Subject: Requesting Class II permissive change for FCC ID: YDUVMTB317

The purpose of this letter is to request a Class II Permissive change for FCC ID: YDUVMTB317。

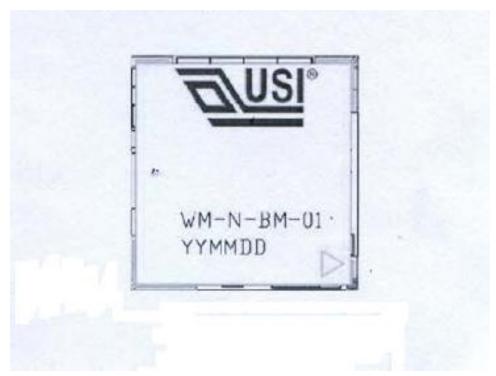
- 1. add the new adapter(Huntkey / HKA01805030-2D)
- 2. The silkscreen of on the shielding was changed
- 3. Added shielding case for WIFI chip.

Original

New added shielding case

Original silkscreen on the shielding for BCM4319

New silkscreen on the shielding after introduce 2Dbarcode:
